SKEP III Home Office Support Site Visit Report

Consultant	Wahib Medanat Consultant Engineer	Rep No.	12-20032022
Contractor	Derar Saraireh & Sons for Engineering & Contracting	Tender No.	(11/2019/USAID/SKEP/3/S) Schools for a Knowledge Economy Project (SKEP) - Phase (3) Package (1, 2)
Site Name	Al Khansa' Basic Mixed School- Al Balqa	Day/ Date	Sun. 20/03/2022
Duration of Project	450 Calendar Days	Total Project Budget	9,789,417.840 JD

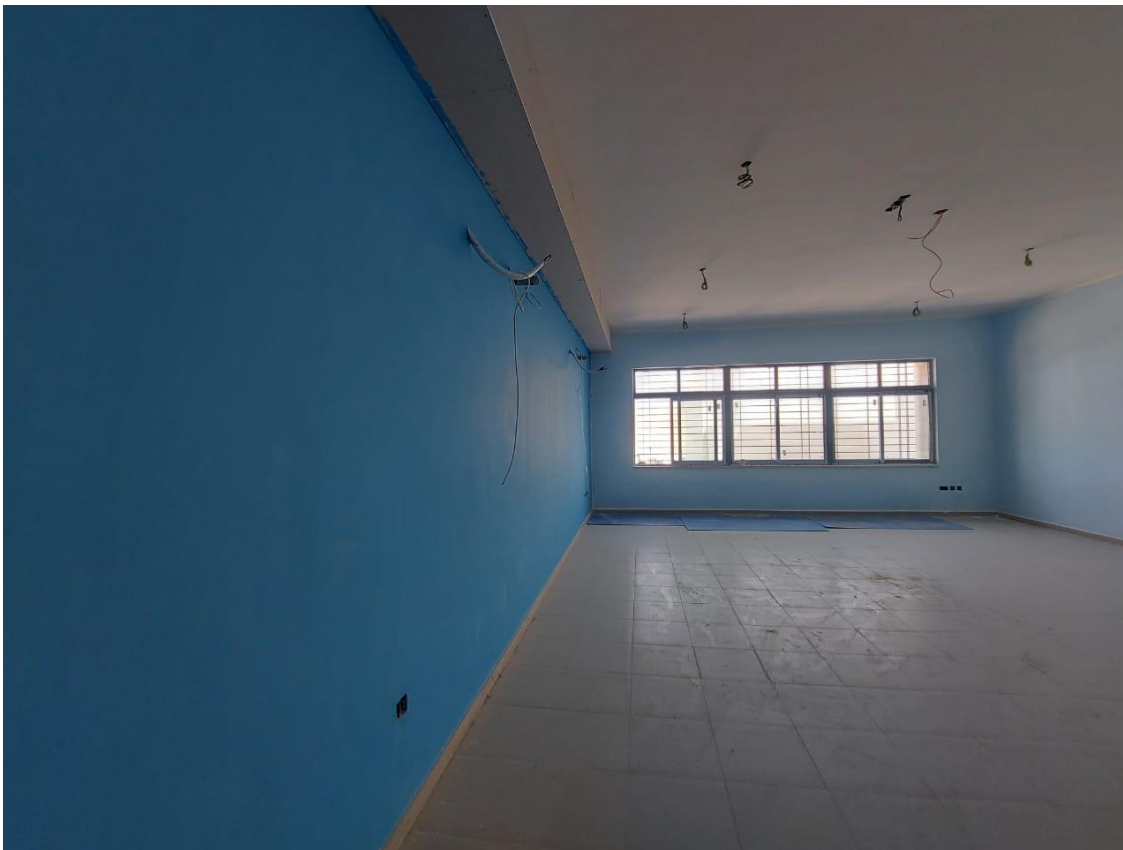
The team observed that due to other activities the stone facades require cleaning
